THE CHARTER

OCT 2025 NMA PACK

GRAVESEND

Existing E01 North Elevation (NMA ref: 20210305)

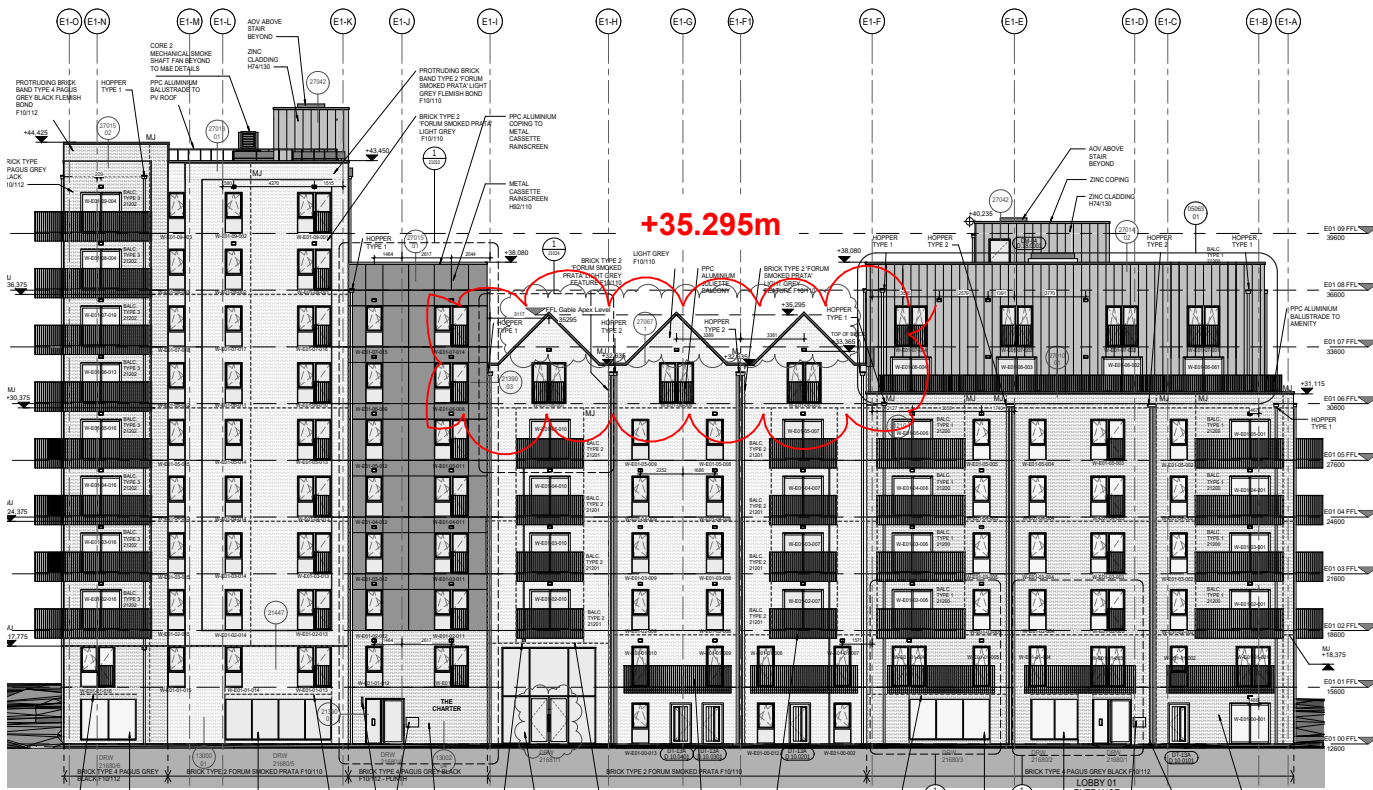
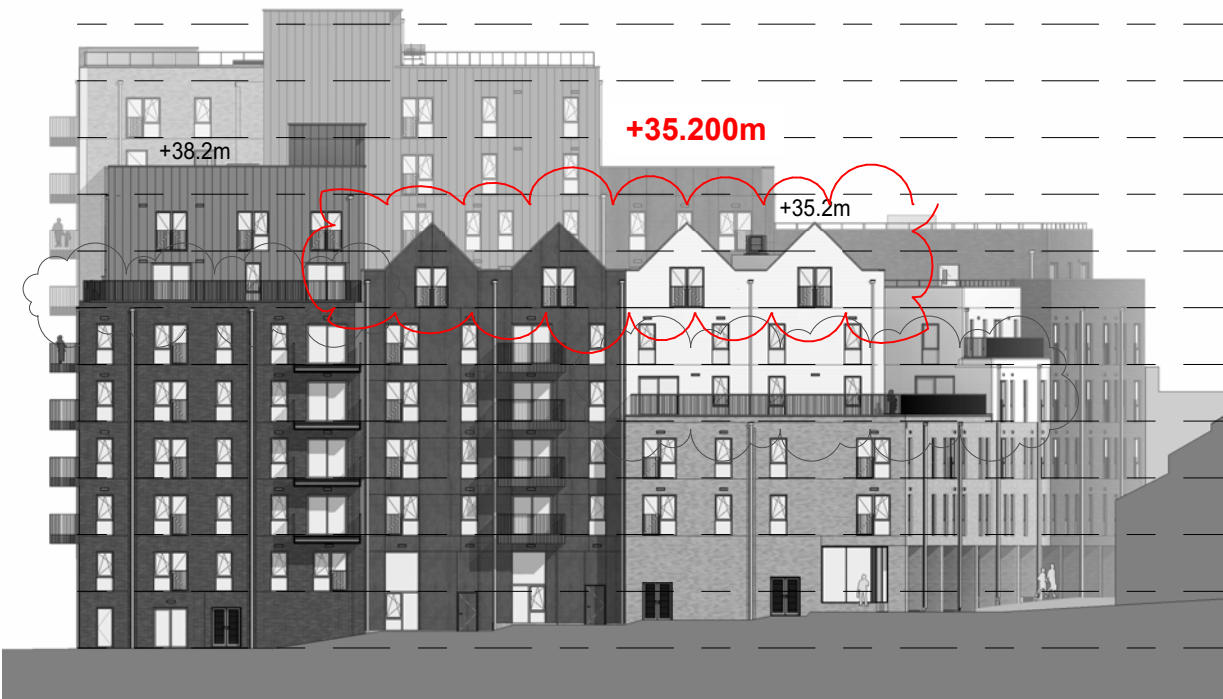
Generally, all roof heights are equal to or lower than the previously approved scheme (NMA ref: 20210305) with the exception of pitched roofs across the development which are slightly higher due to required changes in construction build-up to meet Building Regulation requirements. These increases in height are noted on the following extracts.

Existing E01 Level 01 Plan (NMA ref: 20210305)

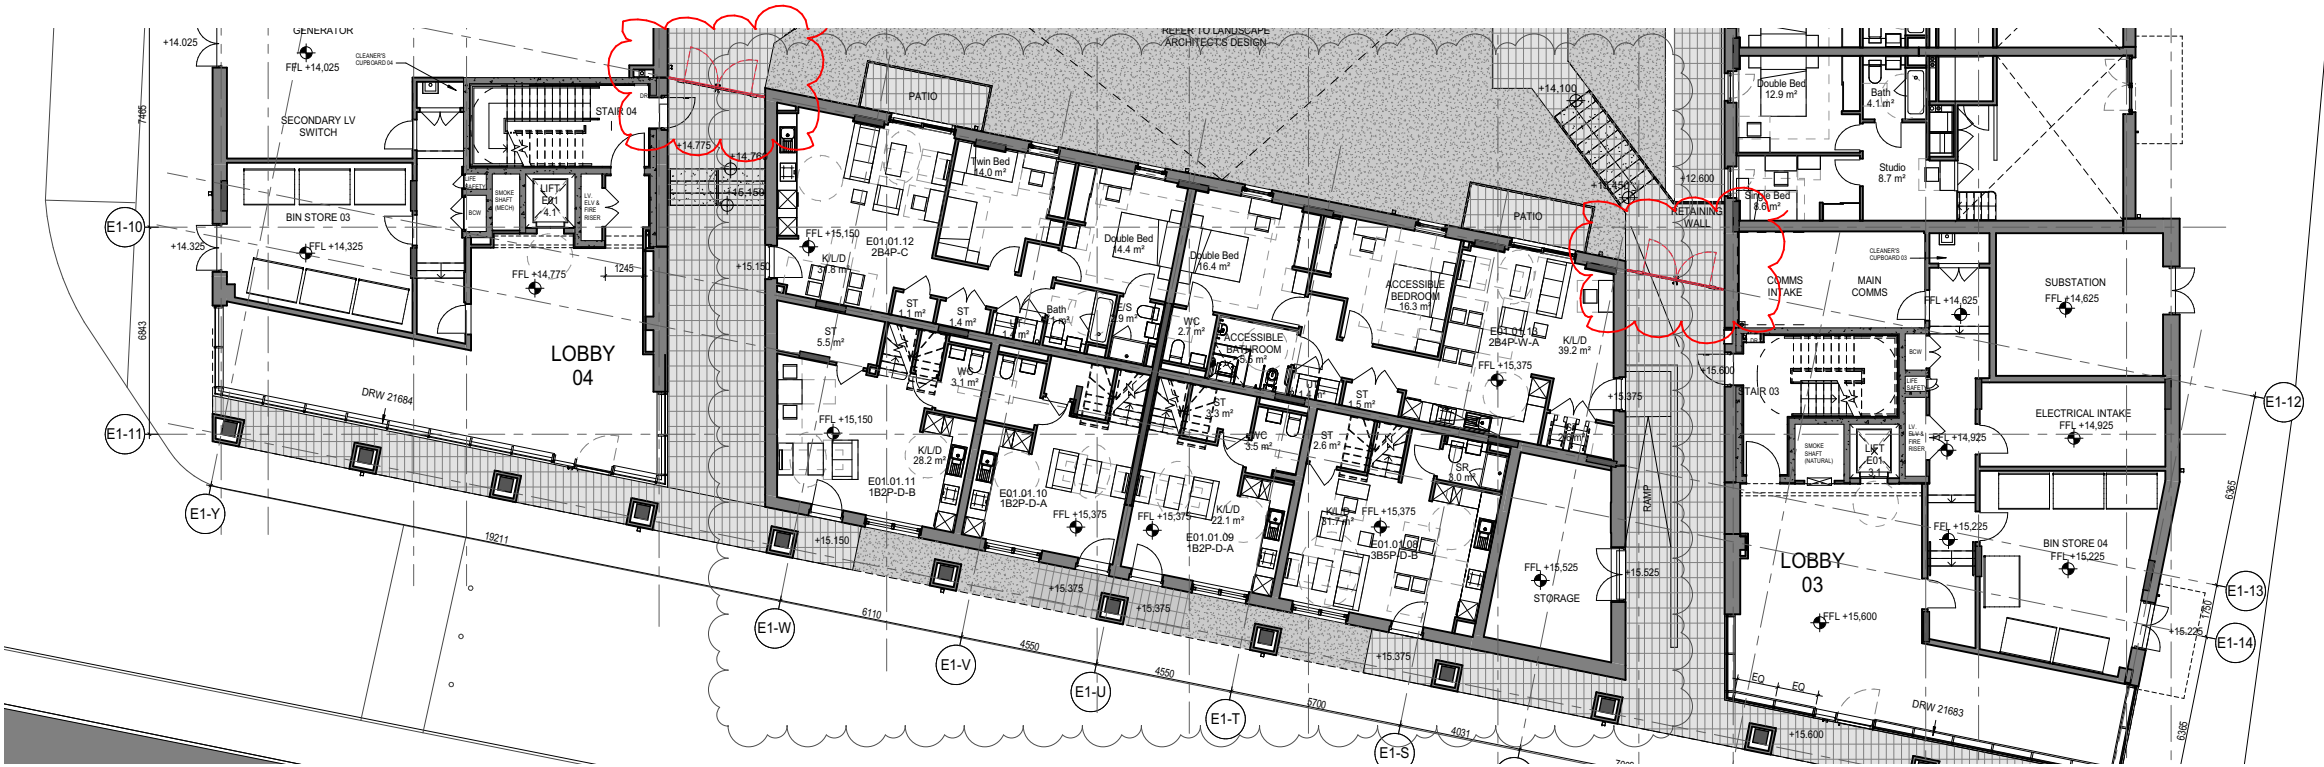
Two external gates which allow controlled access into the development from Market Alley have been relocated for security reasons. By moving the gates closer to Market Alley the opportunities for antisocial behaviour within the public realm area will be reduced making residents feel safer.

Existing E01 Level 01 Plan (NMA ref: 20210305)

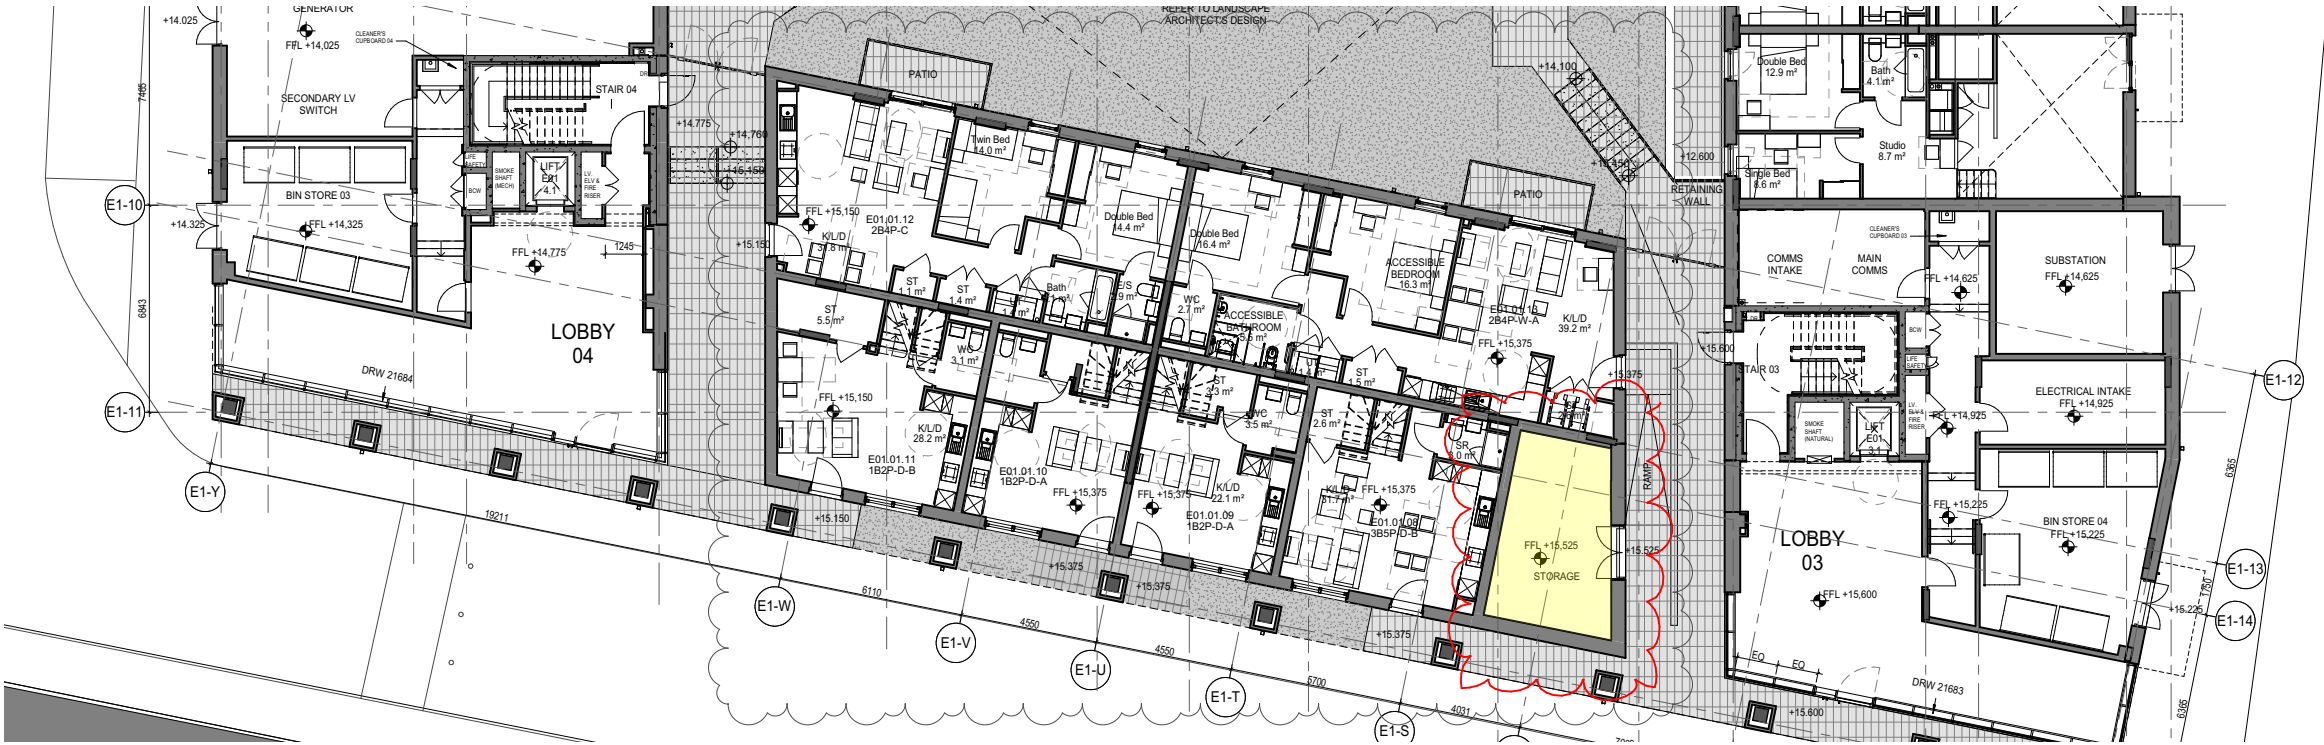
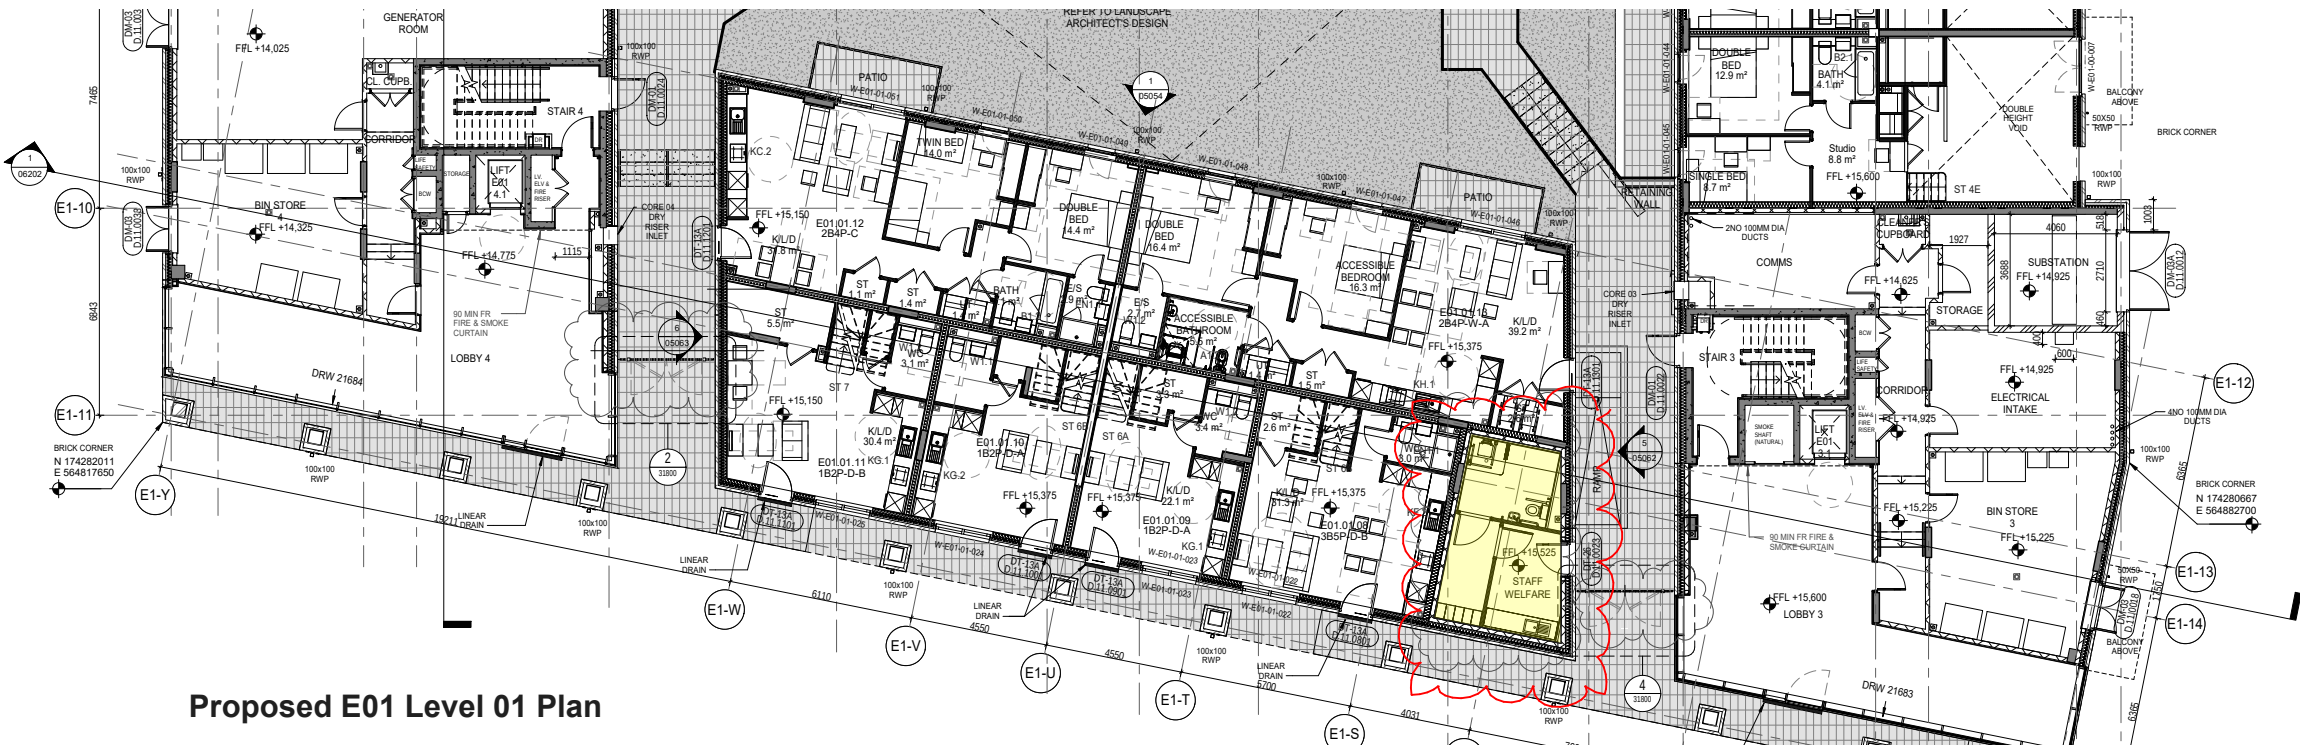
A space in the development, previously identified as a storage room will accommodate a small staff welfare room for on-site management staff. The room will include a small kitchenette, dining area, accesible WC/shower and locker facilities and will have a lockable door located behind the external security access gate.

Existing E01 Level 00 Plan (NMA ref: 20210305)

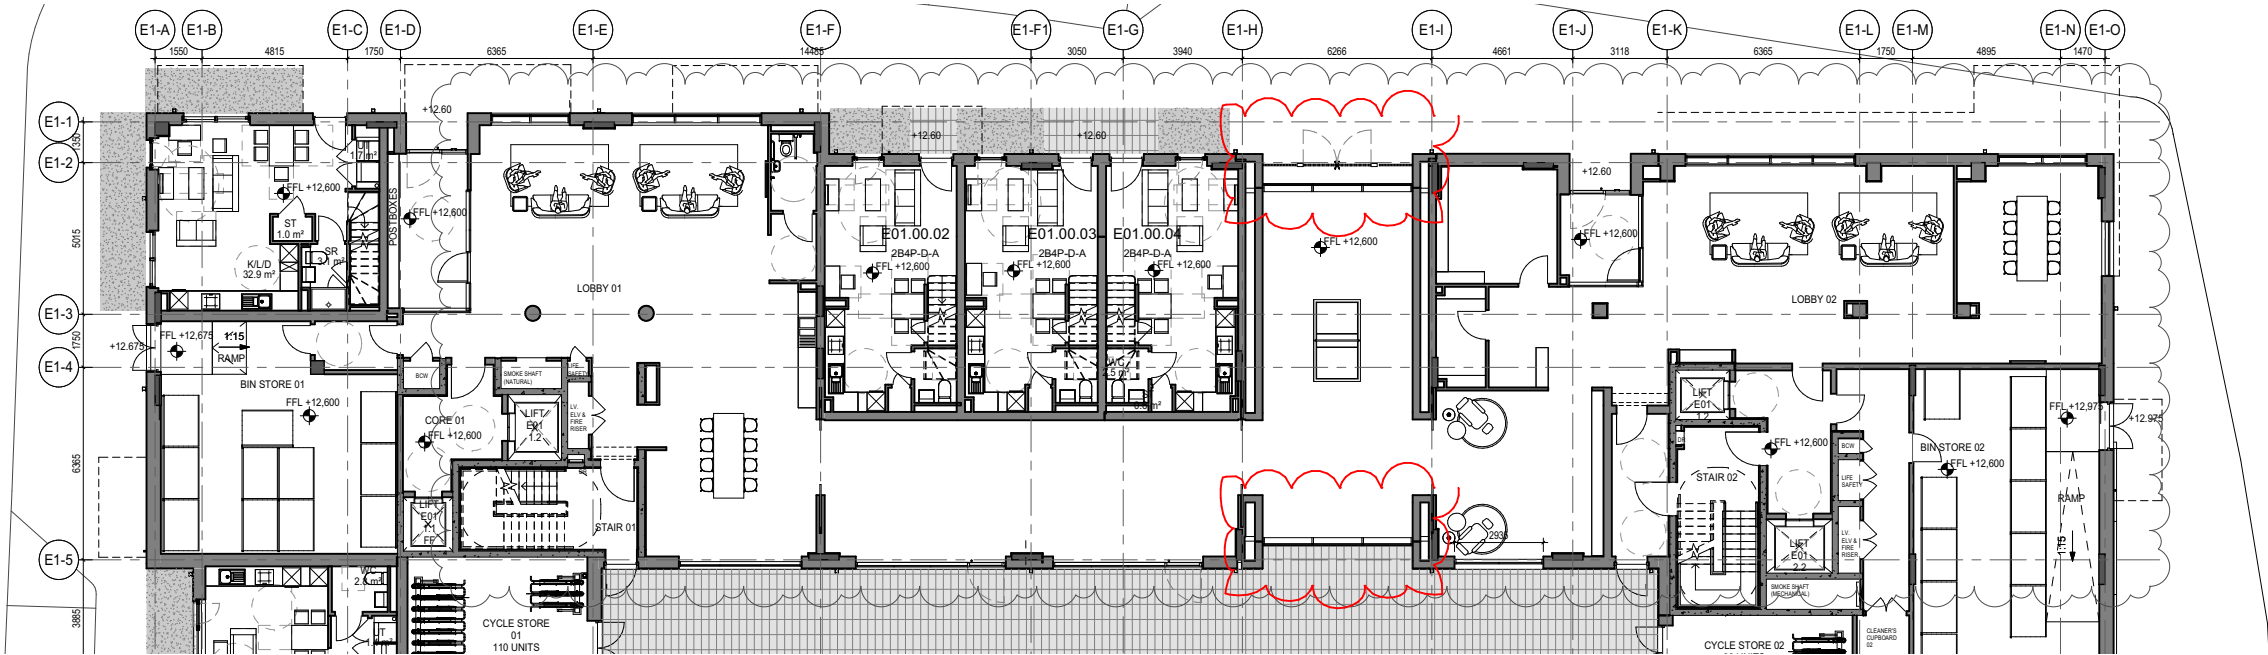
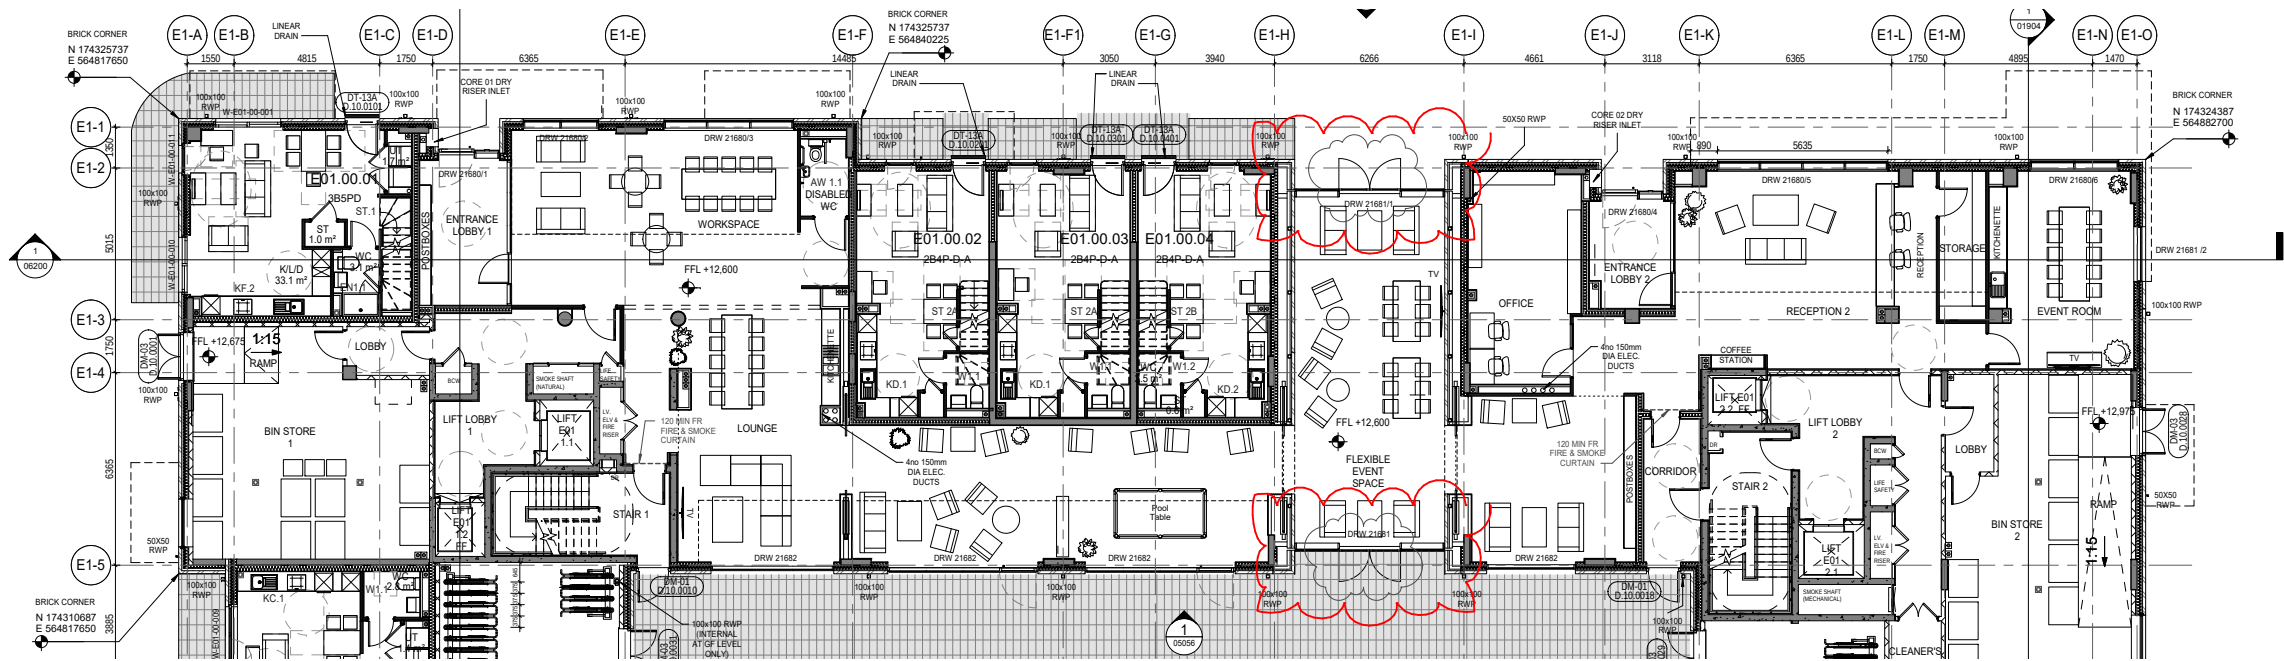
Two new glazed double access doors will be provided on the north and south facades of the double-height flexible event space on the ground floor (Level 00) of Block E01 adjacent to Bank Street. The doors will be part of the full-height glazed wall systems previously consented. This proposal also removes the need for the external gates which were previously shown on the Bank Street elevation which are no longer required.
